NATIONAL STEEL BRIDGE ALLIANCE

AASHTO/NSBA Steel Bridge Collaboration

Fall Meeting Minutes - Combined

Minneapolis, MN

Table 6.6.1.2.3-1—Detail Categories for Load-Induced Fatigue

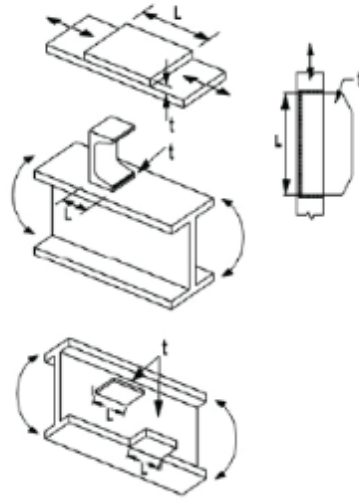
- i. Reference AASHTO 6.6
 - ii. 48"? Comment – Remove Note
 1. Reference G12.1 Constructibility Document & Plate Availability Document White Paper Under Design on NSBA Website
